Town of Bristol, Rhode Island
Department of Community Development

May 25, 2022

RE: Review of Sidewalk Use License: Portside Tavern , 444 Thames street

Portside Outside

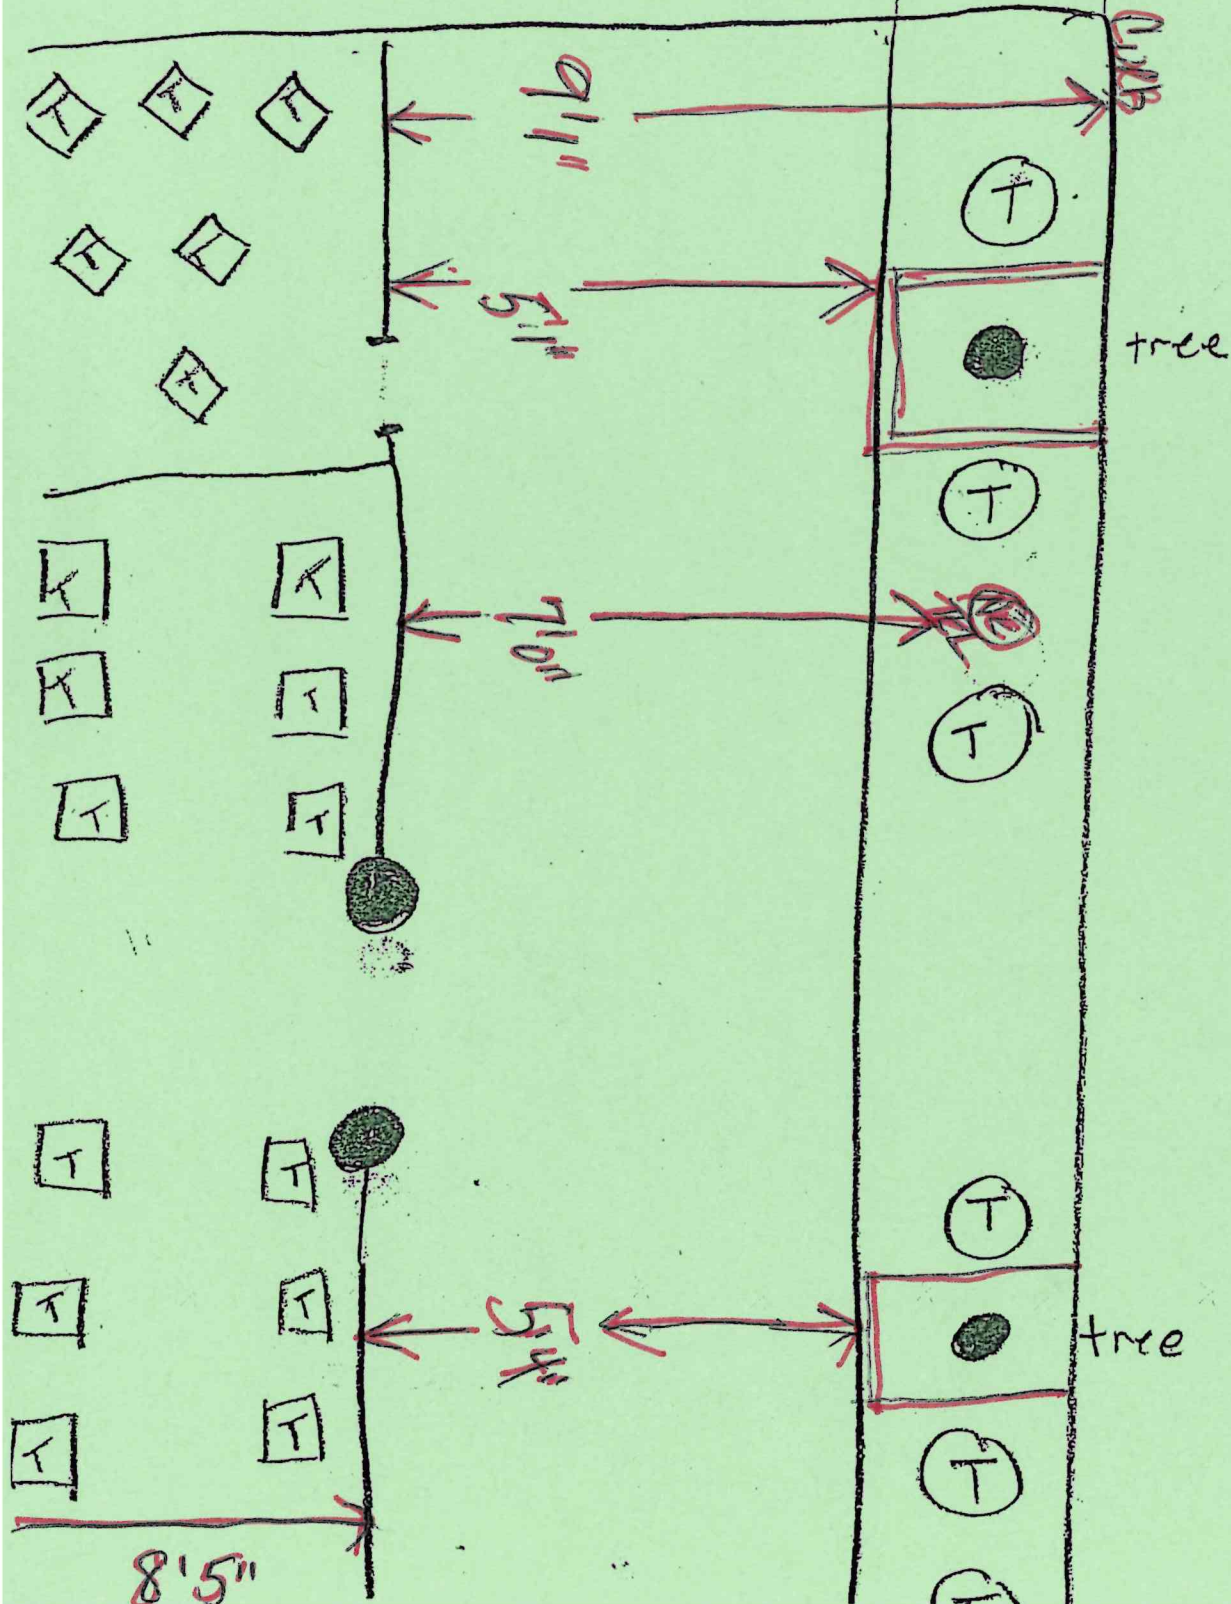
Upon review of the application, we viewed a street/ curbside request for 6 tables with 2 seats each . Each table and chair combo was placed right along the curb directly next to curbside parking (edge of roadway) where patrons would park and open their door into the tables.

Initial measurement from the curb to the Patio property owned by Portside Tavern is 9 feet 1 inch.

The town sidewalk itself is 5'0 from tree, light and pole wooden borders.

Based on the sidewalk measurements and expired one time extension, I would not recommend seating along the edge of the roadway.

~~TABLE 3'1 1/2"~~

• ORIGINAL Sketch By Applicant.
• RED - NOTATIONS By Ray Falco
